# Performance Solution Report

## Ark Group

25 Old Perth Road, Bassendean WA 6054

1 December 2020

Figure 1: Snapshot from Architectural Plan of the Ground Floor detail with the stairway to the Upper Lounge highlighted in orange

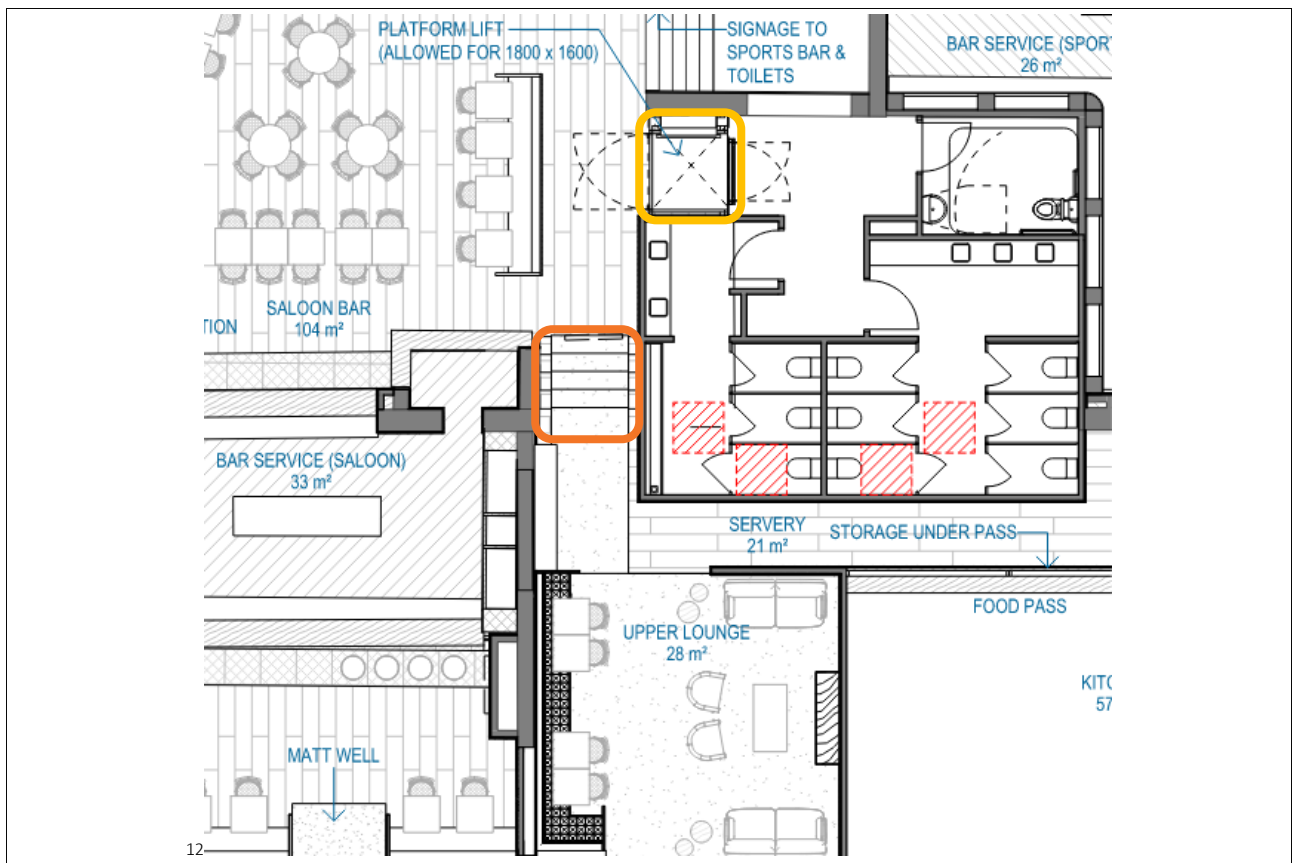
- Given the inherent variation in levels at the existing Bassendean Hotel, upgrading this aged building to eliminate the levels would require extensive structural works.
- The space necessary to incorporate a ramp, given the level change of around 800mm, would be extensive, with no functional space to do so.
- There is no available space to install a low-rise platform lift adjacent the existing stairway, nor the available stairway width to install a stairway platform lift (see orange highlight on Figure 1).
- A lift is documented to provide access between most of the hotel premises, i.e. between the Sports Bar and Saloon Bar, significantly enhancing and extending the accessible areas of this hotel inclusive of both internal and alfresco areas (See yellow highlight on Figure 1).

Figure 2: Proposed Snug layout

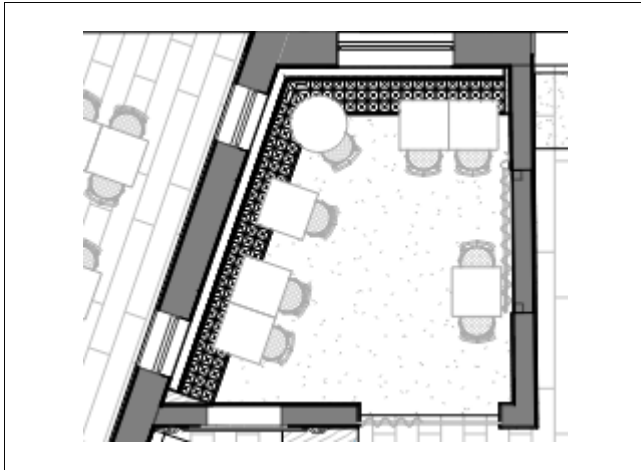
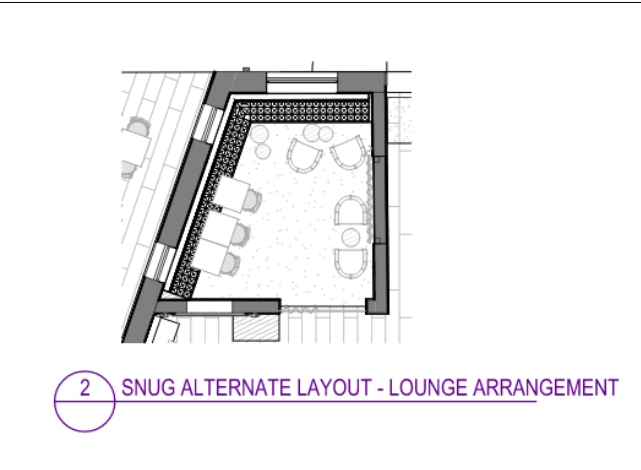
- As two similar lounges have been incorporated in the design that offer the same amenity, it is deemed reasonable that for a person with a disability, to the extent that stairs cannot be negotiated, the Snug Lounge is available on the ground floor. The design team have provided alternative layout options, allowing flexibility of use for the Snug (See Figure 2 and 3).
